1. My full name is Jane Elizabeth Bowen.
2. I have been asked by the Director-General of Conservation (DGC) to provide ecological/technical evidence on the potential effects on fish passage and īnanga spawning of the proposal.

9. I have been asked to provide evidence in relation to the notified consent and the DGC's submission on the potential effects on freshwater conservation values of the proposal by Environment Southland (ES) Catchment Management Division to dam and divert coastal waters and to occupy the coastal marine area with tide-gates and a weir upstream of the Titiroa River.
10. My evidence addresses the following issues:
 - a. Significant indigenous freshwater values of the area;

Figure 4 Total extent of predicted inanga habitat within the Titiroa catchment

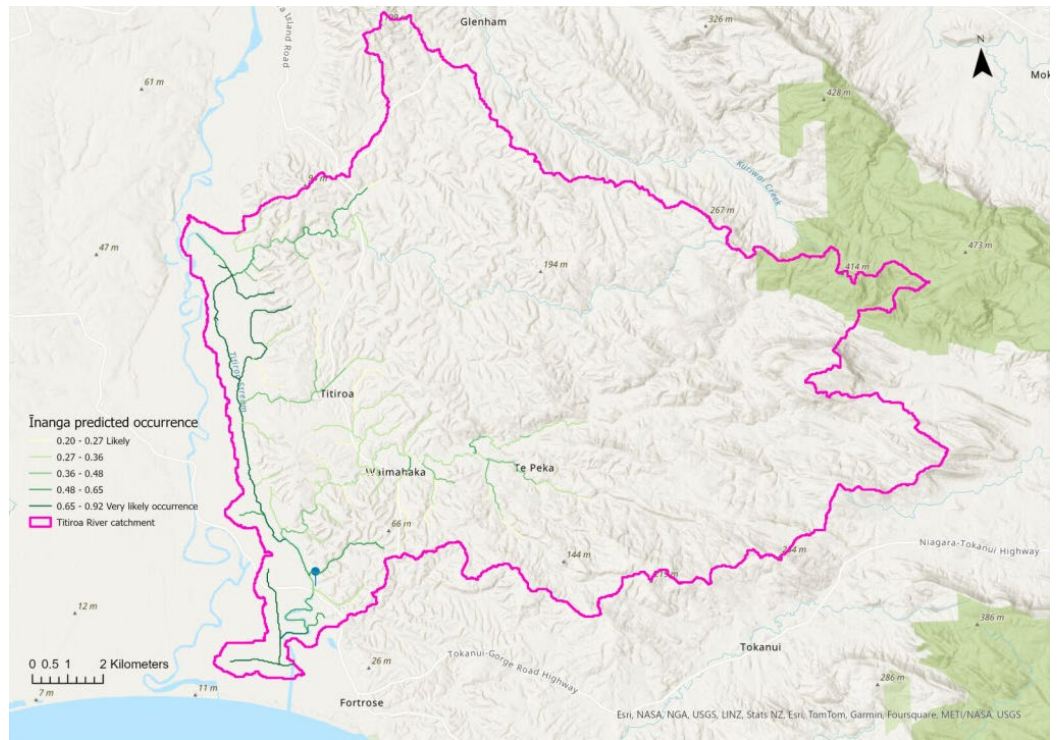
23. There is significant freshwater habitat extent upstream of the Titiroa tide gates. For example, measurements using GIS predictive models (Leathwick et al., 2010) indicate that the total extent of available īnanga habitat upstream of the tide gates totals approximately 100 km as shown in figure 4. Probability of capture models (Leathwick et al., 2008) indicate that there is habitat upstream of the gates particularly suitable for īnanga, longfin eel, shortfin eel and common bully as shown in Figure 5.
